Proposal #32: 9250-12-61
Mellen - Hurley
Ashland Co Line to Upson Lake Road
STH 77
Iron County

This is Addendum No. 02, which provides for the following:

ADDENDUM NO. 02

9250-12-61

Addendum No. 02
ID 9250-12-61
Revised Sheet 22
May 1, 2023

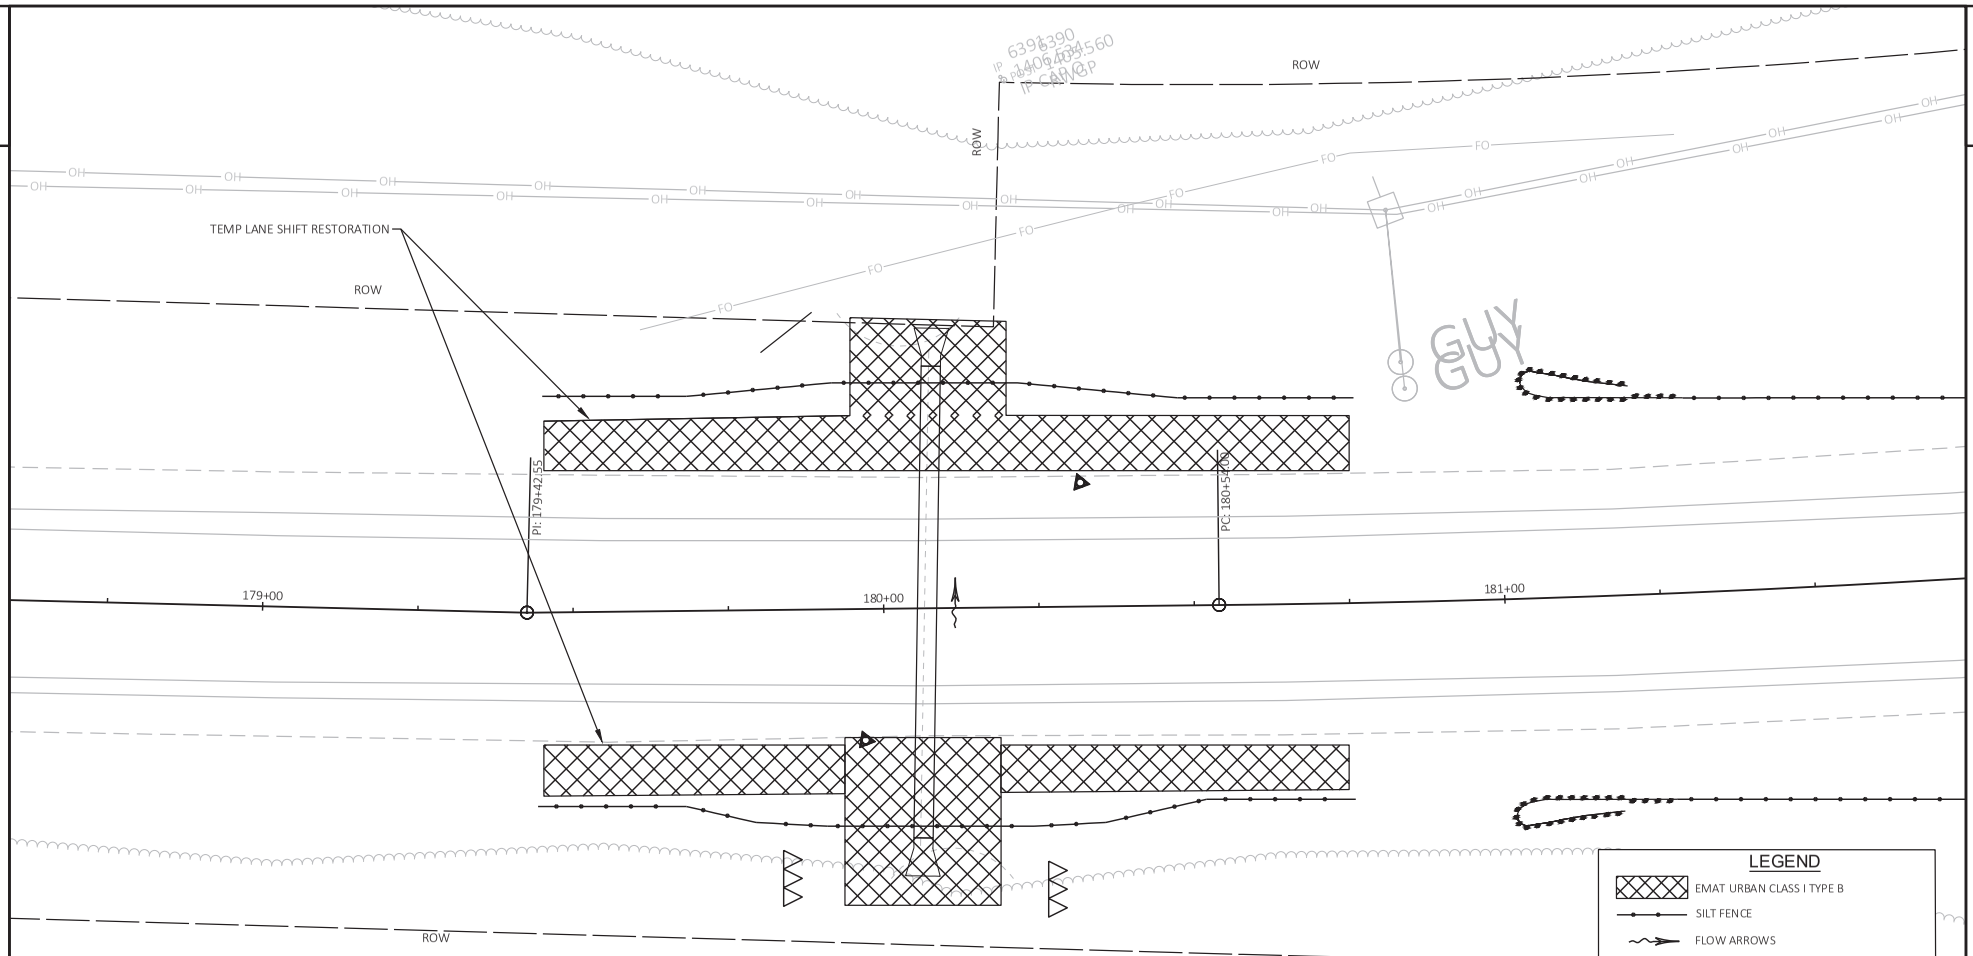
Revised Plan Sheets	
Plan Sheet	Plan Sheet Title (brief description of changes to sheet)
22	Changed length of silt fence and labels for small animal turnarounds
27	Changed length of silt fence and labels for small animal turnarounds
28	Changed length of silt fence and labels for small animal turnarounds
32	Changed length of silt fence and labels for small animal turnarounds
43	Added “Removing Silt Fence” and revised “Silt Fence” quantity
48	Changed length of silt fence and labels for small animal turnarounds
49	Changed length of silt fence and labels for small animal turnarounds
51	Changed length of silt fence and labels for small animal turnarounds
52	Changed length of silt fence and labels for small animal turnarounds
54	Changed length of silt fence and labels for small animal turnarounds
56	Changed length of silt fence and labels for small animal turnarounds
57	Changed length of silt fence and labels for small animal turnarounds
